Subject:	IA20201006a – LF Optima Strength - incorrect Cable Retainer				
Product Brand: Life Fitness	Product Market Segment: <input checked="" type="checkbox"/> Commercial <input type="checkbox"/> Consumer		Organizational Distribution: <input checked="" type="checkbox"/> LF Subs <input checked="" type="checkbox"/> ISO's/IIO's <input checked="" type="checkbox"/> Distributors <input checked="" type="checkbox"/> Dealers <input type="checkbox"/> Customers		
Time Required:	<input type="checkbox"/> No Time <input checked="" type="checkbox"/> 5 Min <input type="checkbox"/> 10 Min <input type="checkbox"/> 15 Min <input type="checkbox"/> 30 Min <input type="checkbox"/> 45 Min <input type="checkbox"/> 1hr <input type="checkbox"/> 1,5hr <input type="checkbox"/> 2hr <input type="checkbox"/> 2hr+				
Problem Code:	-	Internal Reference:	QHOLD-15	Affected region:	Global
Doc. Number: IA20201006	Doc. Revision: a	Doc. Revision Date: 2020-10-06	Pages: 3	Author: Fran Keijmes	Departmental Distribution: <input checked="" type="checkbox"/> Installation <input checked="" type="checkbox"/> Service <input type="checkbox"/> Sales

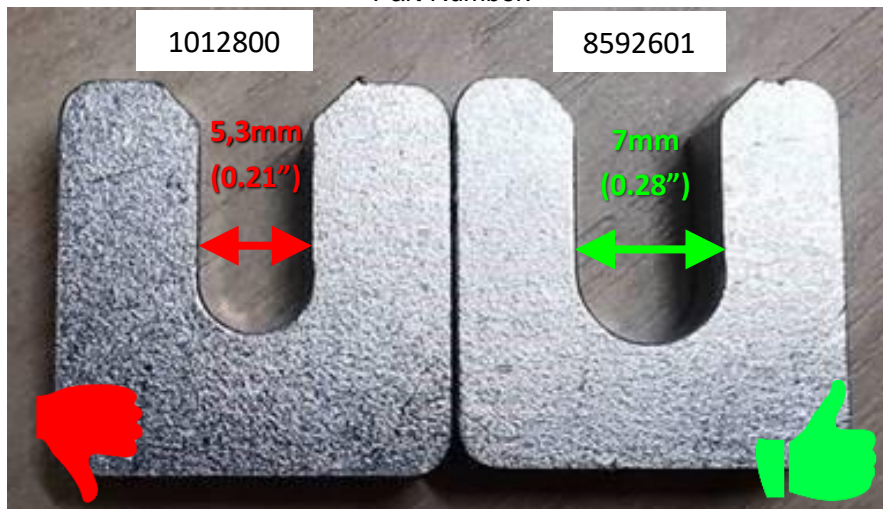
For a small range of Optima Strength products, it's possible that the wrong version Cable Retainer was included within the box. When this is the case, this means that the assembly of the product can't be finalized. The correct part is needed to be able to finalize the product assembly.

This Cable Retainer is located inside the Cam on the working arm and holds the end of the cable into place.

Note: As it's unclear if all affected units include the incorrect Cable retainer, it's possible that affected products have been delivered with the correct Cable Retainer.

Measure the width of the inner cut out of the Cable Retainer. The correct width is 7mm (≈0.28 Inch). If the cut out is around 5,3mm (≈0.21 Inch) then the Cable Retainer is incorrect, which then needs to be replaced by the correct one (Part Number 8592601). The incorrect Cable Retainer can be disposed.

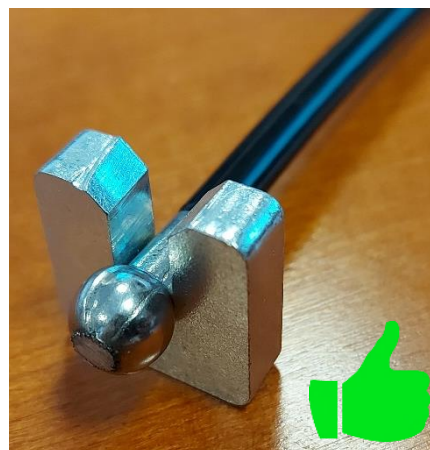
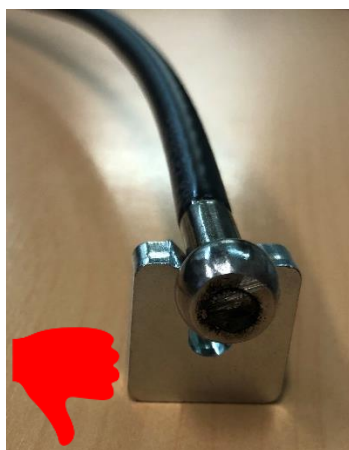
Before the installation takes place, open the box and find the Blister Pack containing the Cable Retainer. Measure the width of the cut-out of the Cable Retainer, as described above.

If the incorrect Cable Retainer was added to the Blister Pack, remove it from the Blister Pack and dispose it. Add the correct Cable Retainer to the Blister Pack with (preferably) transparent adhesive tape. Make sure the Cable Retainer will not fall out of the Blister Pack. Put the Blister Pack back into the box and close the box.

If the correct Cable Retainer was added to the Blister Pack, put the Blister Pack back into the box and close the box.
